Application for Variation of an Environmental Permit

PWP ITEM NO. 6461TH
CENTRAL KOWLOON ROUTE – MAIN WORKS

**Supporting Document for Application of
Variation of Environmental Permit No. EP-457/2013/C**

圖則編號 plan no. Diagram 1	比例 scale 示意圖 DIAGRAMMATIC
© 版權所有 COPYRIGHT RESERVED	
HIGHWAYS DEPARTMENT HONG KONG 路 香港 政 署

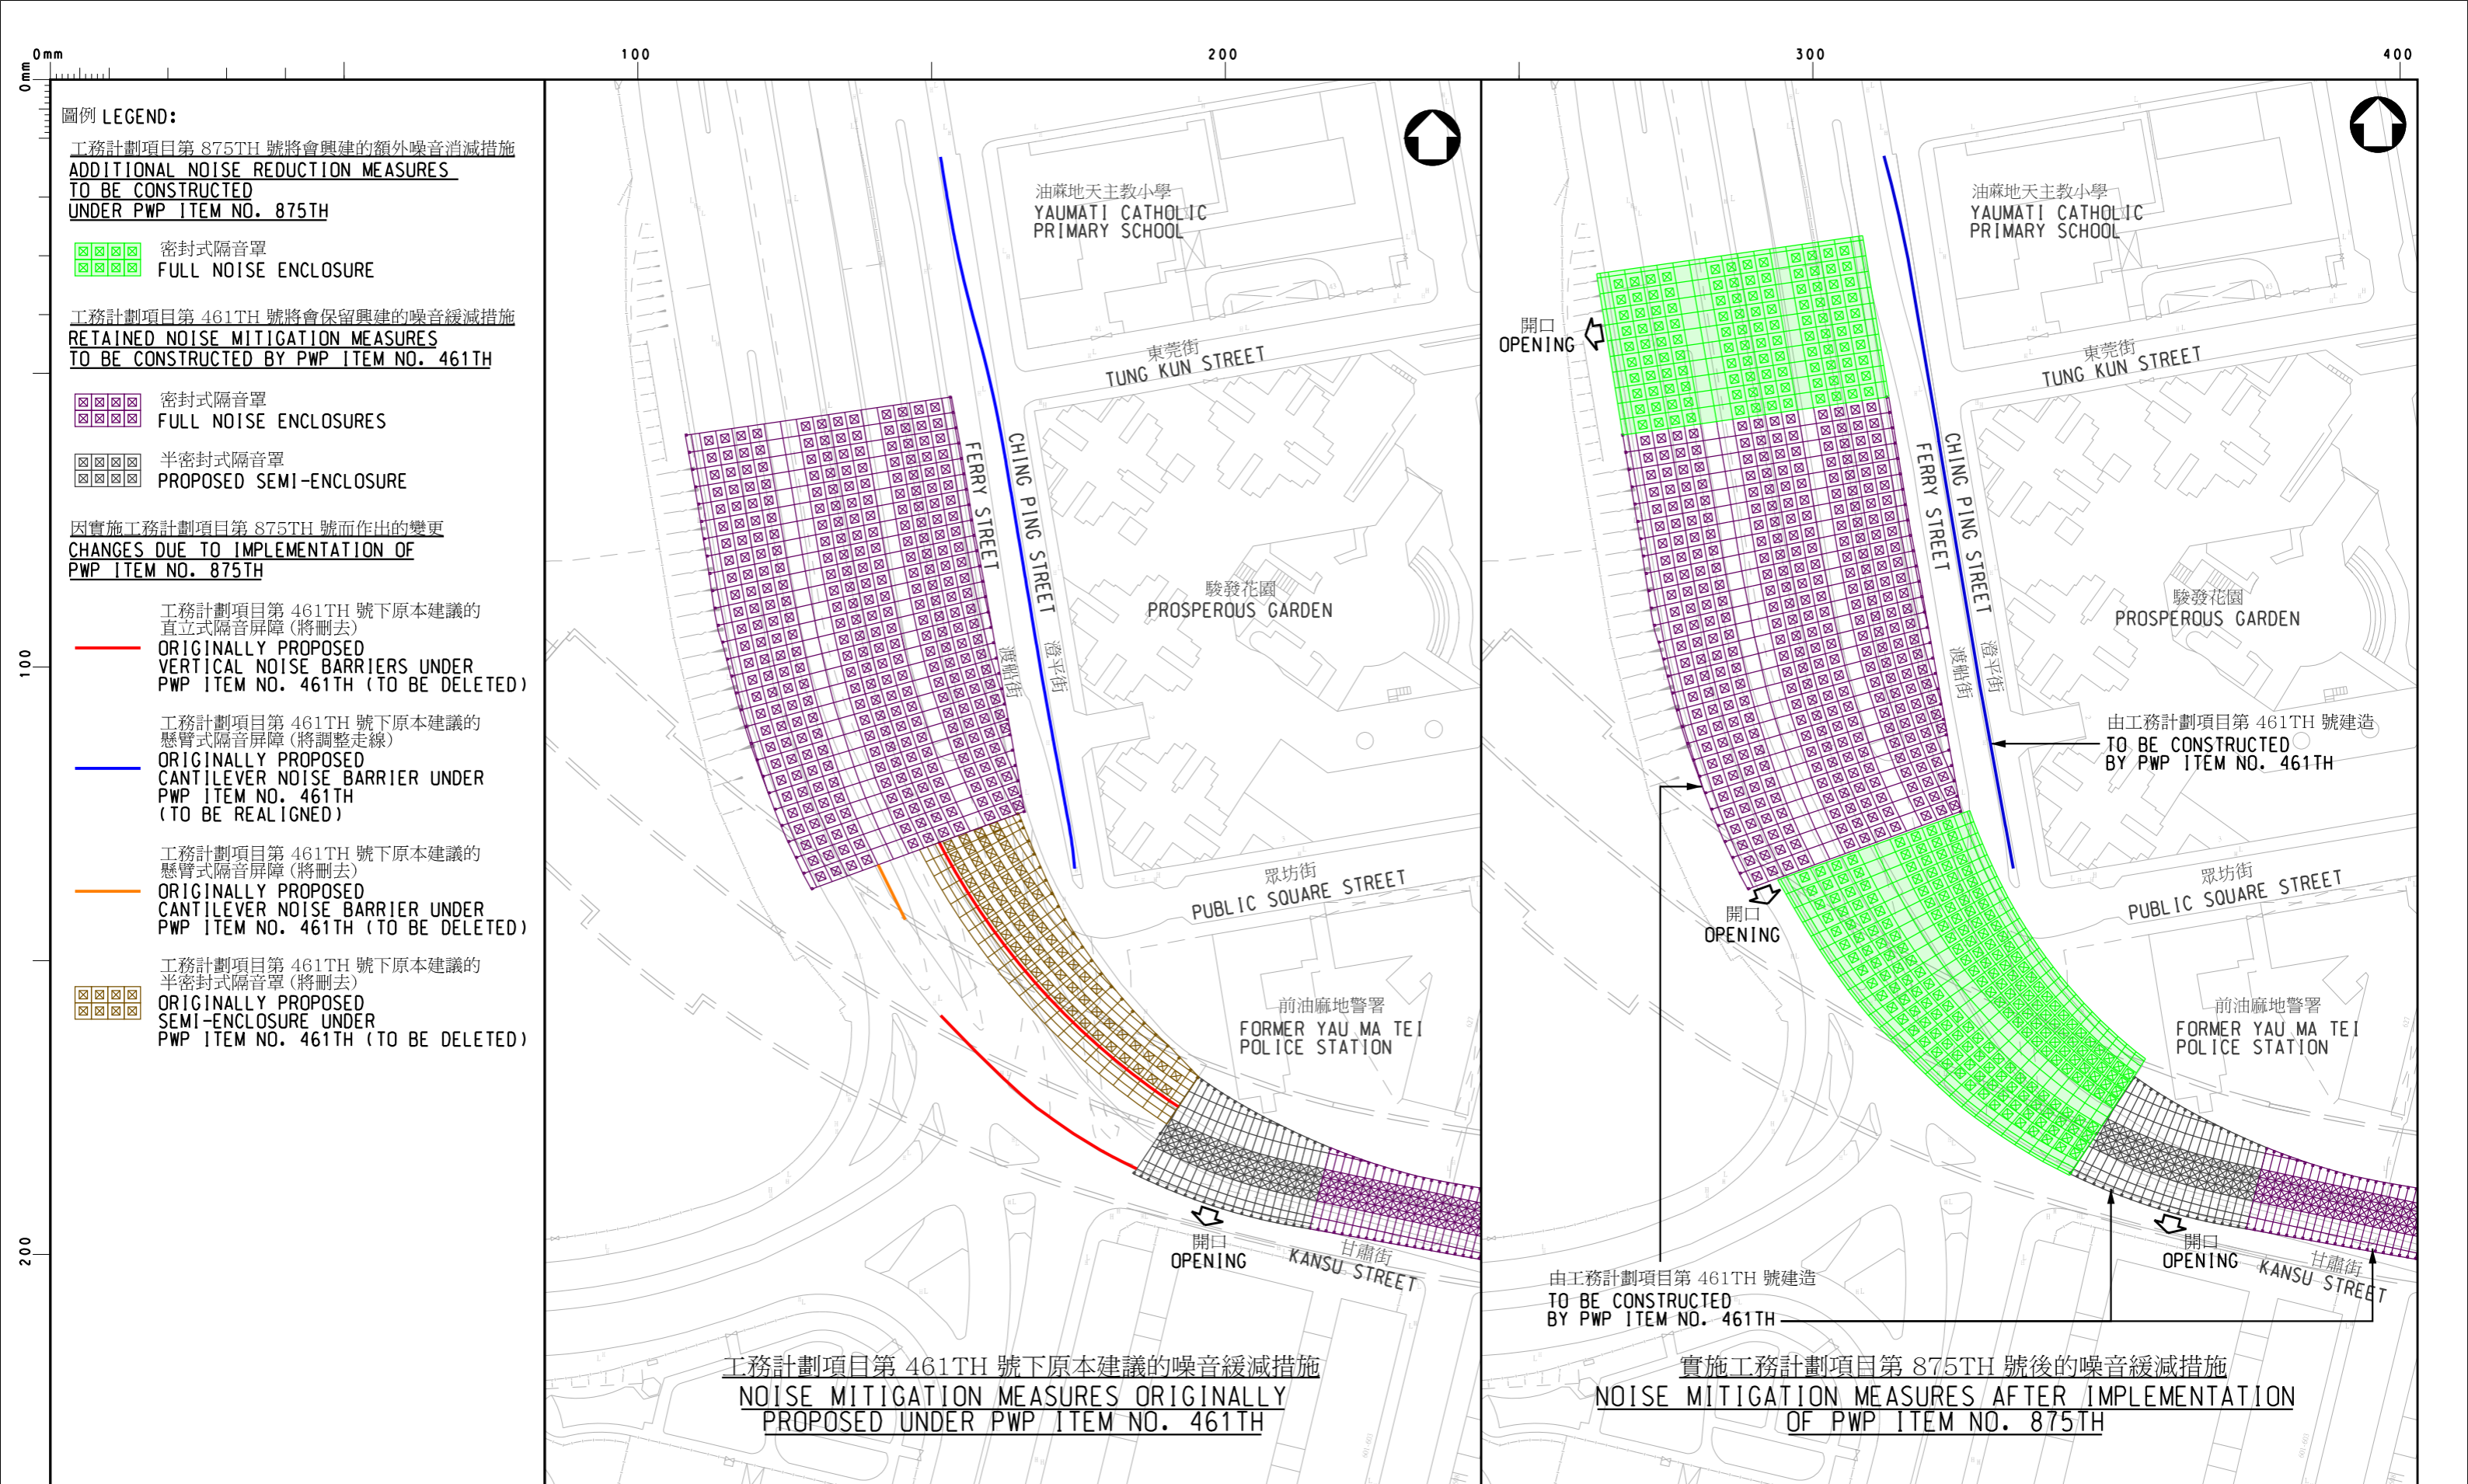
- 3.1.2 As shown in Diagram 1, implementation of the additional noise reduction measures under PWP Item No. 6875TH will in effect bring the following changes to the noise mitigation measures set out in the current EP:-

- (i) replacement of the originally proposed semi-enclosure, cantilevered noise barrier and vertical barrier (namely ID S03, C08 and V06 in the EP) at GRF (Ferry Street Section) with a full noise enclosure of approximately 90-metre (m) long;

- (ii) extension of the full noise enclosure (ID F02 in EP) northward by approximately 40m, with 30m length of vertical openings on the side farther away from Yaumati Catholic Primary School (YMTCPs); and

- (iii) reduction of length of the vertical noise barrier (ID V05 in EP) at GRF (Ferry Street Section) due to (i) above, and realignment of the at-grade cantilevered noise barrier (ID C07 in EP) at Ferry Street due to (ii) above.

drawing no. scale
 Diagram 2 1:2000

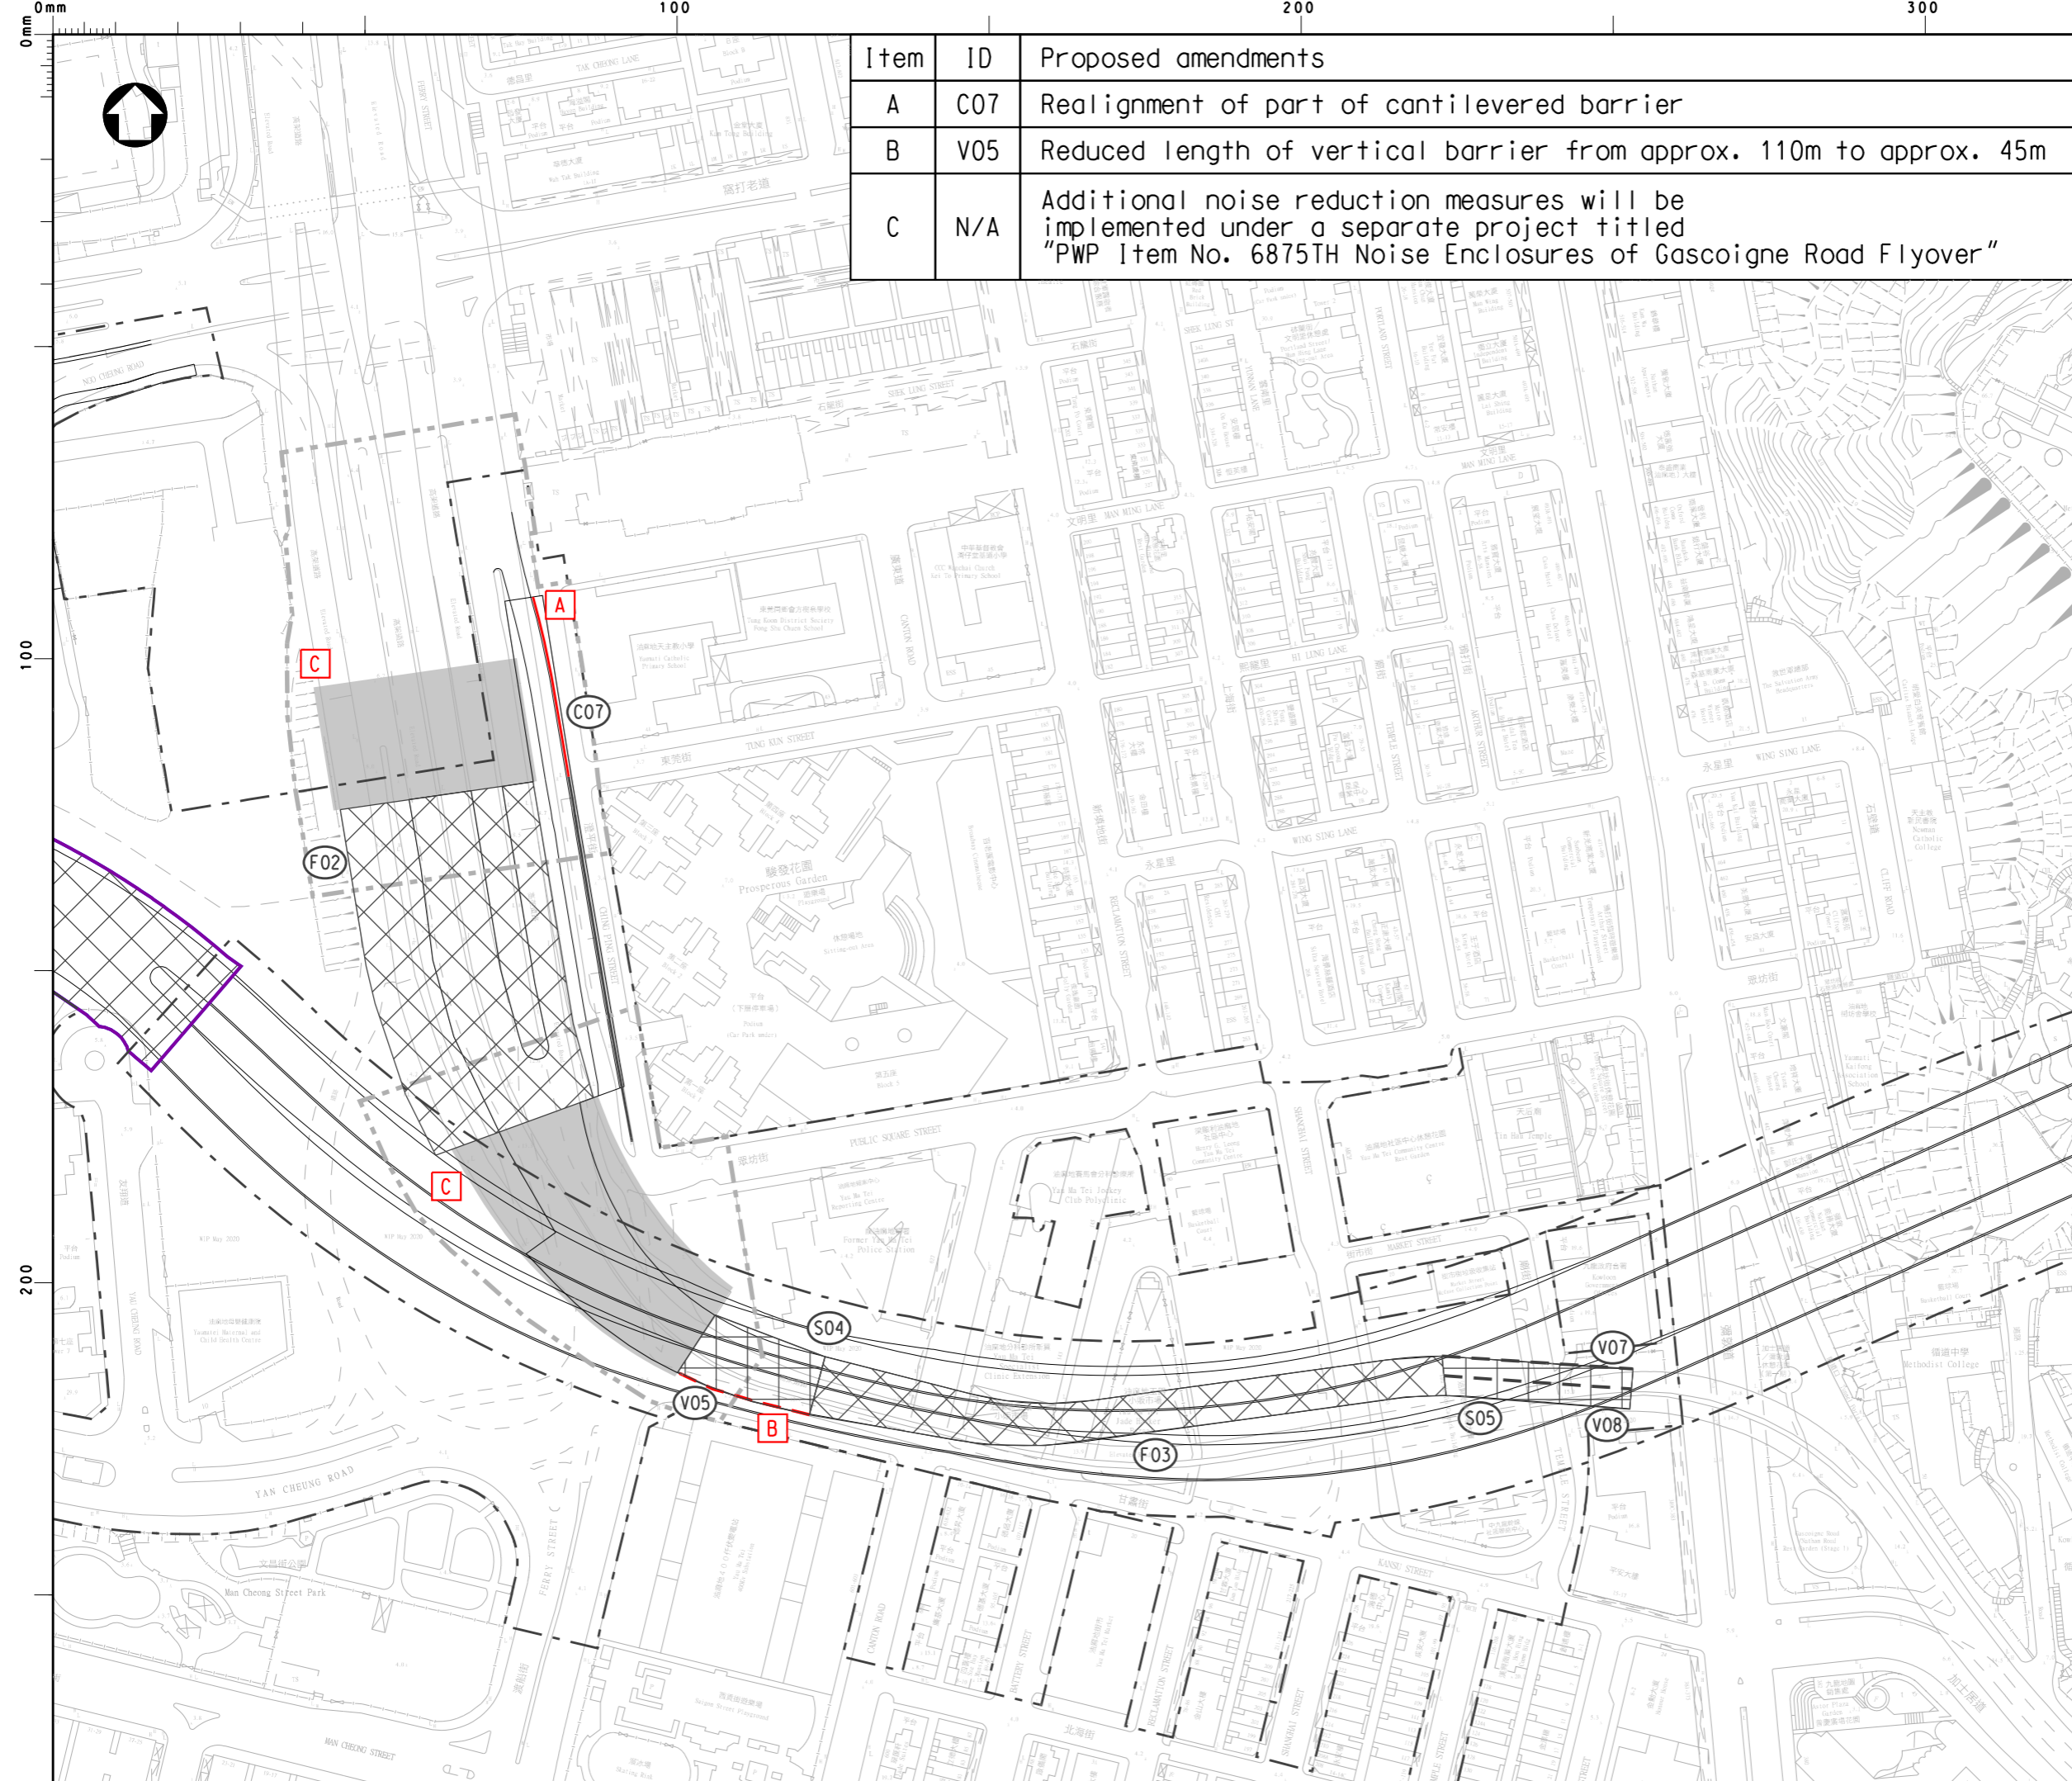
3.1.8 Accordingly, Figure 5c of the current EP will also be amended to reflect these changes. Please refer to Diagram 2 highlighting the proposed amendments (with remarks) and Diagram 3 showing the amended Figure 5c to be adopted in the revised EP.

Item	ID	Proposed amendments
A	C07	Realignment of part of cantilevered barrier
B	V05	Reduced length of vertical barrier from approx. 110m to approx. 45m
C	N/A	Additional noise reduction measures will be implemented under a separate project titled "PWP Item No. 6875TH Noise Enclosures of Gascoigne Road Flyover"
